## **Addendum Number One**

**Date of Issue:** 02/22/13

**Project:** USC Preston College Bathroom and Flooring Renovations  
Project Number: H27-6086-SG

**A101**

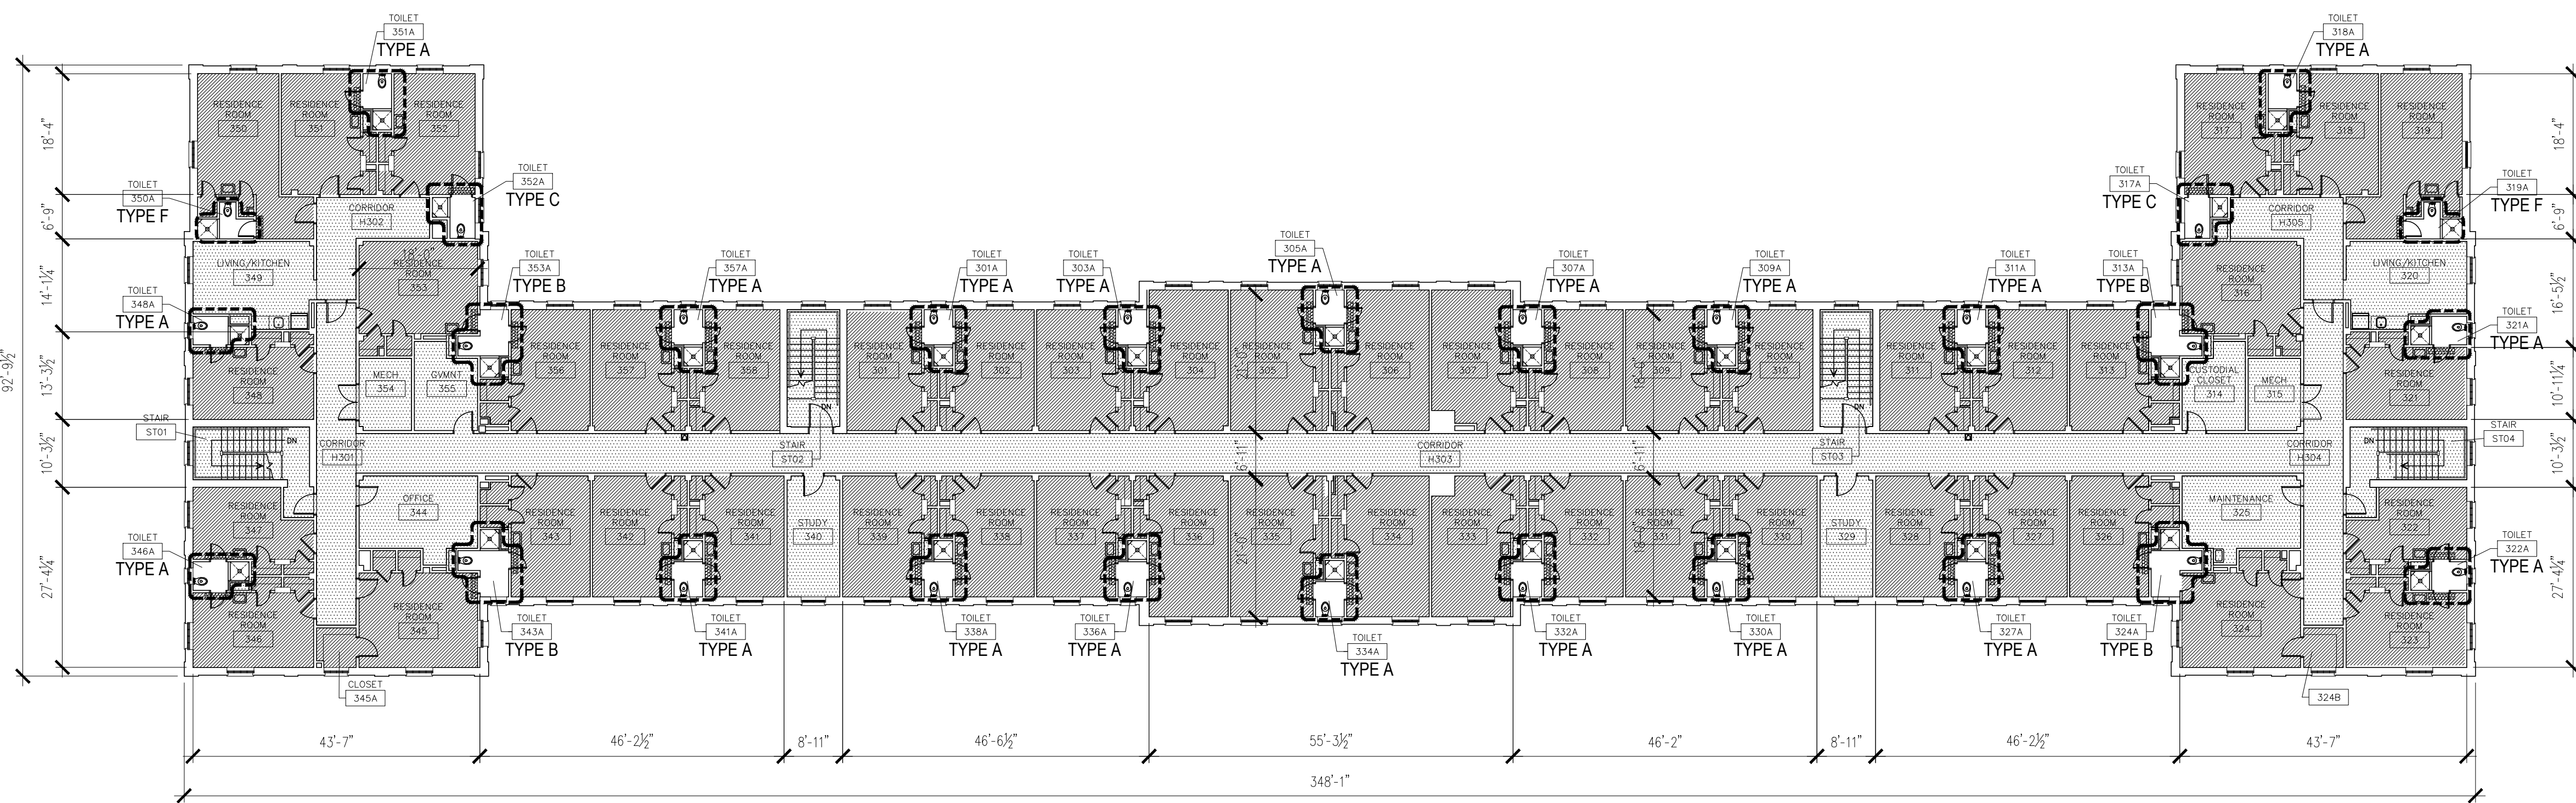
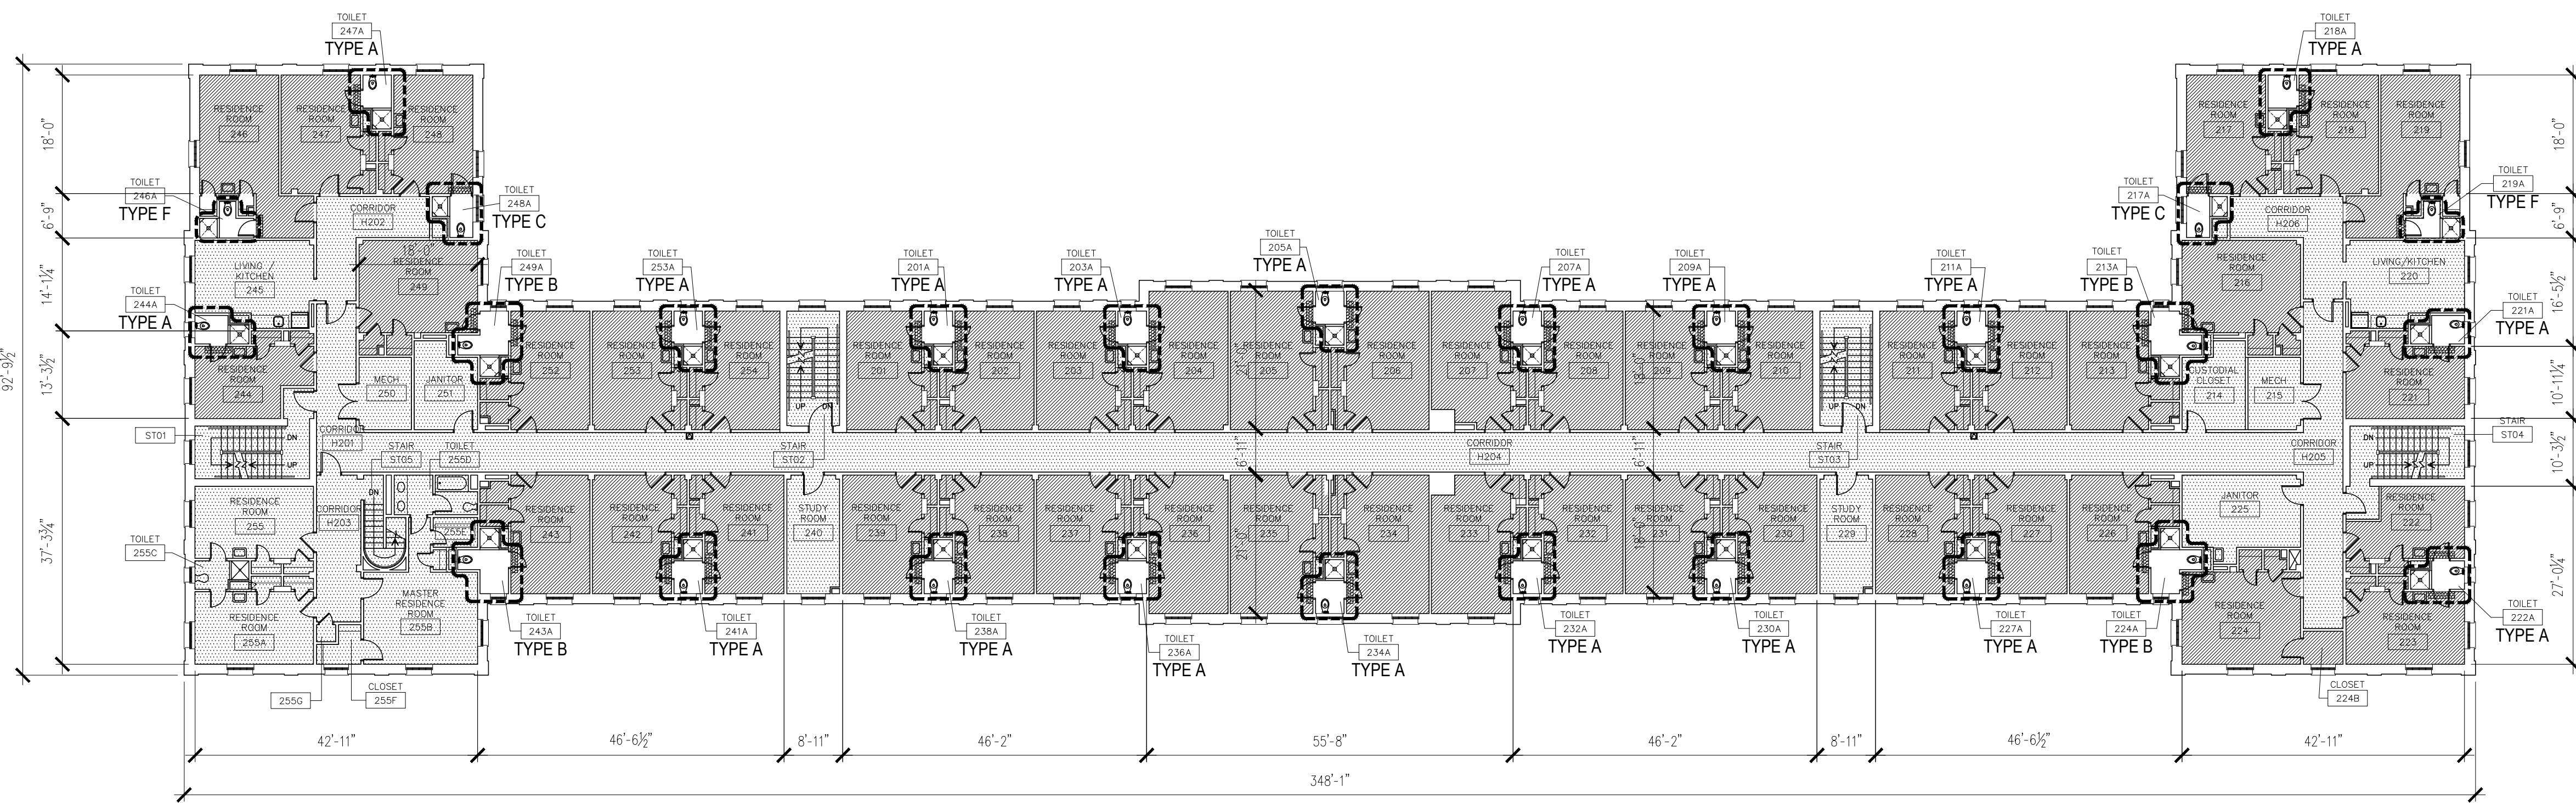
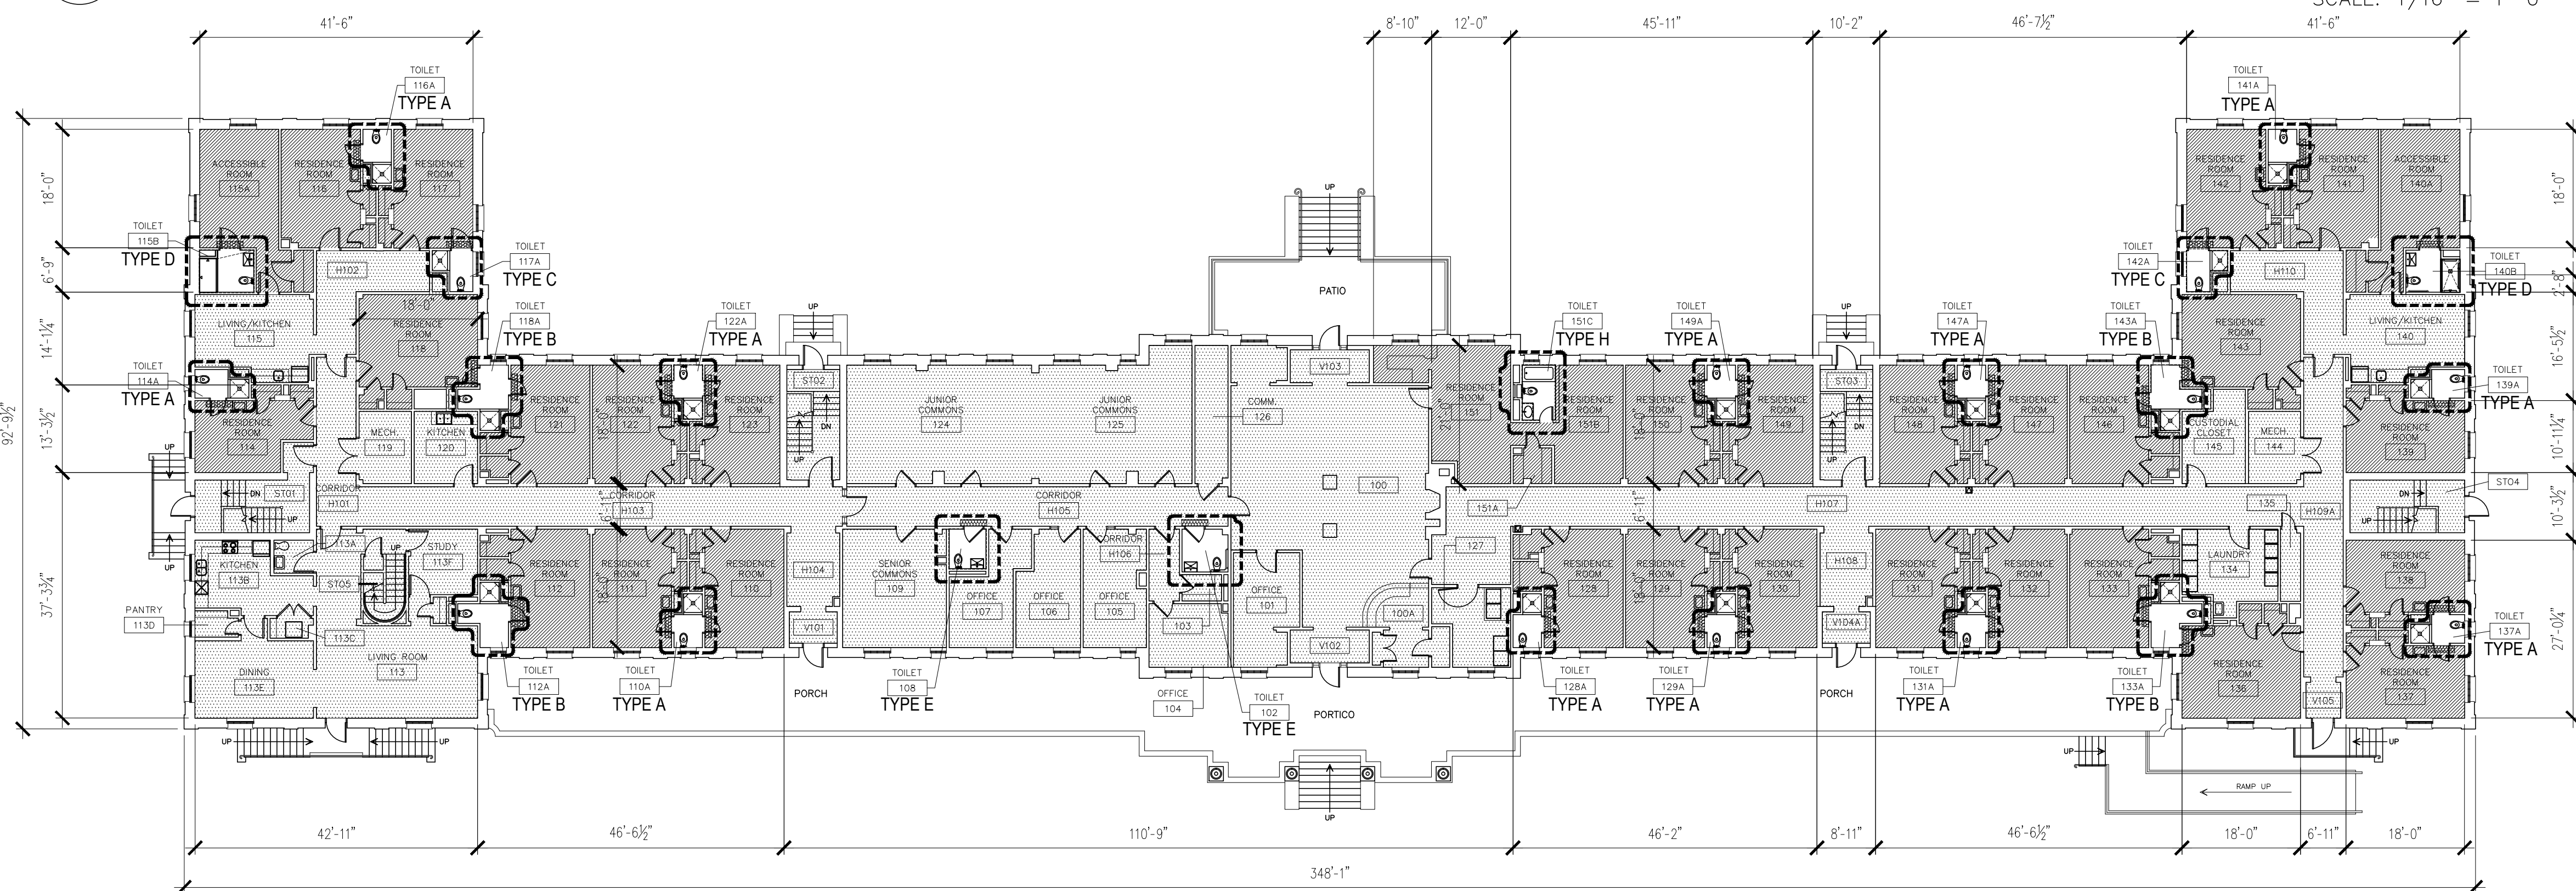
10. **SHEET AD112 / A1** Add keyed note 8.
11. **SHEET A101** Remove and replace with enclosed sheet A101.
12. **SHEET A111** Delete B2/A111 and add Sketch SK-A-002.
